SUBJECT: WESTINGHOUSE ELECTRIC COMPANY – NUCLEAR REGULATORY  
COMMISSION INTEGRATED INSPECTION REPORT NUMBER 70-1151/2018-004  
AND NOTICE OF VIOLATION

Report No.: 70-1151/2018-004

Facility: Columbia Fuel Fabrication Facility

#### Cross-sectional View of HF Spiking Station

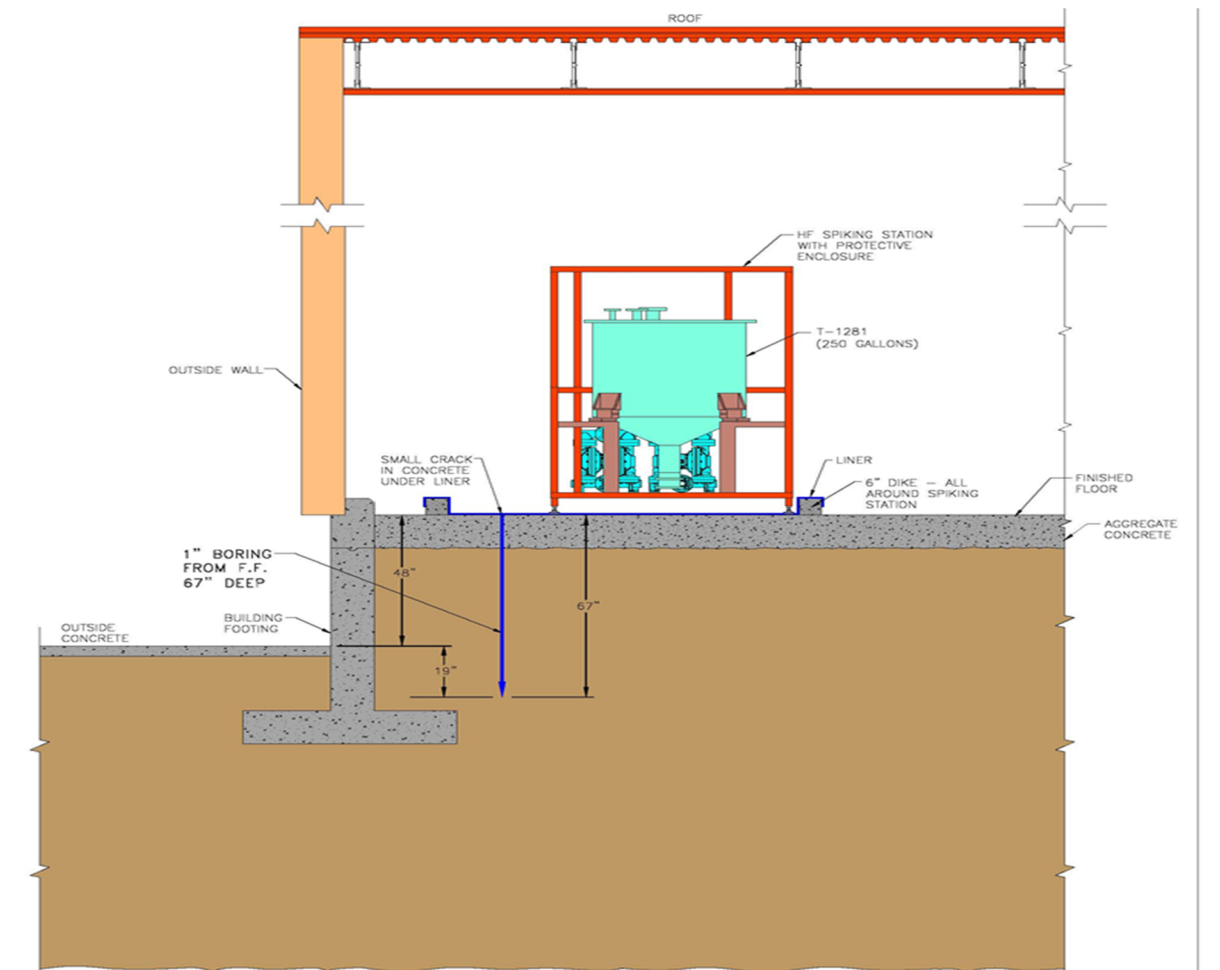
*Description:* On June 16, 2018, approximately 30 gallons of UNH solution leaked into the diked area surrounding the HF spiking station. A flanged piping connection was the source of the leaking solution. After the system was shutdown, a worker identified a small amount of solution that appeared to have migrated to the outside of the dike wall. CAP 2018-11205 was written to track the issue and Spiking Station #2 was shut down. The dike liner was removed as part of corrective measures. While the polypropylene liner was removed for repair work, a small crack was noticed in the epoxy floor covering. The plan was to repair the crack but as the loose epoxy was chipped away, a hole of approximately 3 inch diameter was revealed.

ADUHFS-902 had management measures applied in the form of annual inspections of the liner in accordance with OM 81215, “SI-Safety, HF Spiking Station Pad Liner.” These inspections check the dike liner for evidence of tears, penetrations, or seam separation. The inspectors reviewed the three previous year’s inspection results and noted that the inspections failed to identify the degraded condition of the liner. A review of the liner following the event indicated a penetration through the liner which allowed UNH to migrate to between the liner and the concrete floor. In addition, the inspectors

noted that portions of the liner had been previously repaired with numerous patches, indicating that damage to the liner had occurred in the past. The inspectors noted that the annual inspection provides repair instructions, however, testing of the liner is not conducted following repairs.

ADUHFS-902 was considered degraded as indicated by cracks and degradation of the concrete dike wall. The inspectors noted that there was no policy or procedure in place to periodically inspect the area below the liner for indications of degradation of the concrete floor due to liner leaks.

- OM81215 was updated to 1) clarify the steps needed to perform the liner leak check, 2) require notification to Environmental Health and Safety (EH&S) of any degradation, and 3) change the frequency of the inspection from annual to quarterly and following any repair.
- The Spiking Station was barricaded and posted with instructions to put down walking pads prior to stepping on the liner to prevent liner damage.
- Hourly inspections of the liner have been commenced while the spiking station is in operation.

- Develop and implement an improved design for the spiking station system and dike area including a design review to prevent UNH solution from impacting the environment.
- Assess similar design configurations of a liner/environmental barrier relied on for secondary containment for proper post-maintenance and time-based PMs.
- Conduct an extent of condition for similar couplings used throughout the facility to verify PMs have been established.
- Additional long term corrective actions are detailed in ACA 2018-12123.
